24 September 2018
WRL Ref: WRL2017018 L20180924

**Water Research
Laboratory**

WRL Response to Hume Coal 'Response to Submissions'

Figure 1: Bias in model calibration and potential implications for uncertainty analysis

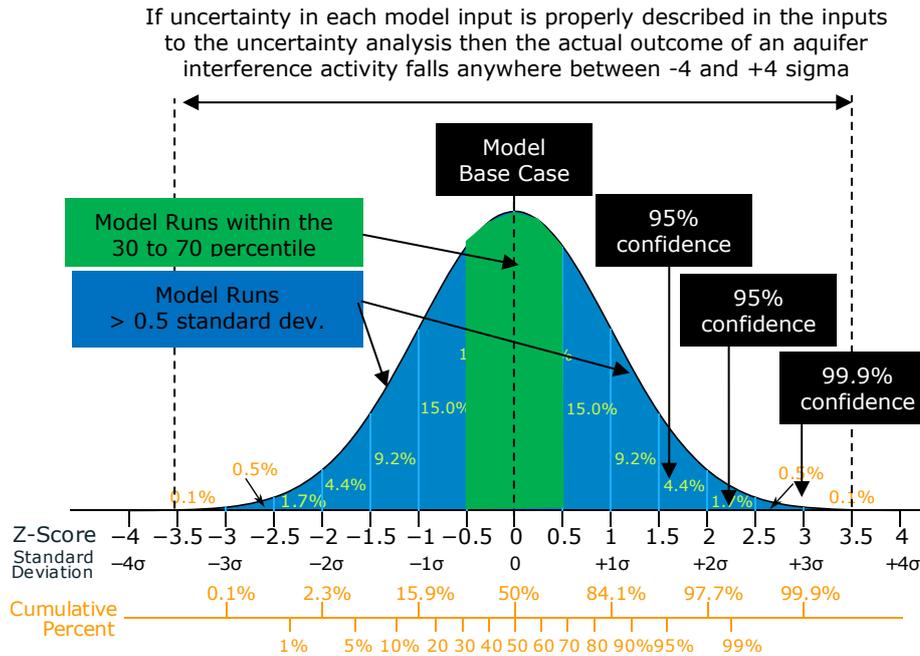
In the opinion of WRL's reviewer, one arbitrary and irrational filter applied by some consultants is the the 33-67 percentile (one standard deviation) of all monte-carlo model runs 'rule'. For this rule to be applied wisely the sum of all available field observations, data analysis, model conceptualisation and simplification in a numerical simulator must result in a modelling tool base case that deviates from various measures of reality by no more than 17% (67% - 50%). Since the accuracy of a model can not possibly be known in advance (hence the reason for undertaking an uncertainty analysis), and especially if hypothesis testing of assumptions has not been demonstrated, truncation of results may result in the true prediction being excluded from consideration as is illustrated in Figure 1.

Therefore, while some modellers may contend that the sum of all available measurements and model conceptualisation does result in a prediction that is within 17% of reality, this would appear to be in conflict with the peer reviewed advice of Bredehoeft (2005). It must also be recognised that most groundwater models are constructed from data collected at just a handful of boreholes that usually measure much less than 0.001% of the earth's surface within the study domain and therefore rely on extensive interpolation and extrapolation. Furthermore these models are often based on time series observation data that have limitations in coverage or quality and which are frequently not analysed to the fullest extent possible which can lead to substantial model bias (Rau et al., 2018). Most numerical models also employ great simplification in spatial distributions of geology and hydraulic parameters and temporal variability in boundary conditions that may allow one variable (e.g. mass balance) to be well predicted but another not so well (e.g. drawdown). Therefore, again, truncating uncertainty analysis results is very unwise.

Therefore, given that measurement errors are additive, and models may be based on substantial measurement and/or simplification, interpolation and extrapolation errors that introduce bias, and especially then without any reporting of hypotheses testing of key assumptions, WRL's reviewer recommends that NSW DPE consider the 5th to 95th percentile predictions of impact reported by the proponent for the Hume Coal Prospect and not the 33rd to 67th percentile.
